UNITED STATES PATENT AND TRADEMARK OFFICE

APPLICATION NO.	FILING DATE	FIRST NAMED INVENTOR	ATTORNEY DOCKET NO.	CONFIRMATION NO.
10/526,845	04/27/2007	Minchu Sonnenschein	0-05-037	9356
42009 7590 10/05/2009 KEVIN D. MCCARTHY ROACH BROWN MCCARTHY & GRUBER, P.C. 424 MAIN STREET 1920 LIBERTY BUILDING BUFFALO, NY 14202				
EXAMINER				
LOW, LINDSAY M				
ART UNIT		PAPER NUMBER		
3721				
MAIL DATE		DELIVERY MODE		
10/05/2009		PAPER

Office Action Summary

DETAILED ACTION

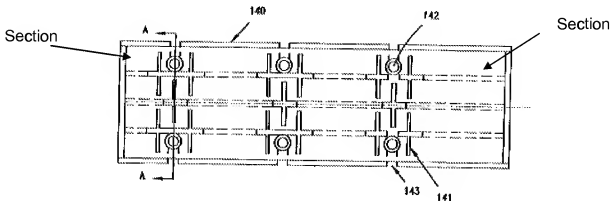
Sonnenschein's staple cartridge has one or more arrays as shown in Fig. 20A. In addition, the cartridge has a facing surface having an area with slots 141 for the staples to be fired and two bores 142 associated with each array. The anvil (see Fig. 18B and 18C) has two locking screws 121 and a facing surface (in the vicinity of holes 116) for the locking screws 121 to be extended. The cartridge has an upper surface level with two sections located at proximal and distal ends of the cartridge as designated below.

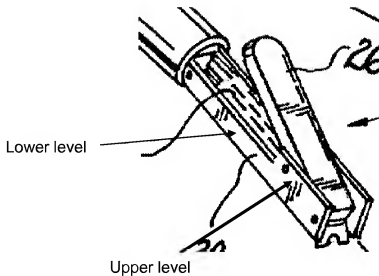
The modified device of Sonnenschein fails to disclose a lower level in the cartridge located above the array of staples. However, Bolanos teaches a cartridge 24, 38 having an upper level and a lower level, where the lower level is above the array of staples (see designations below) for the purpose of keeping an anvil 26 aligned with the cartridge as it is brought into close proximity with the staple cartridge. Therefore, it would have been obvious to one of ordinary skill in the art at the time of the invention to provide a lower level to Sonnenschein's staple cartridge for the purpose of aligning the anvil with the cartridge as it is being brought into close proximity with the staple cartridge.
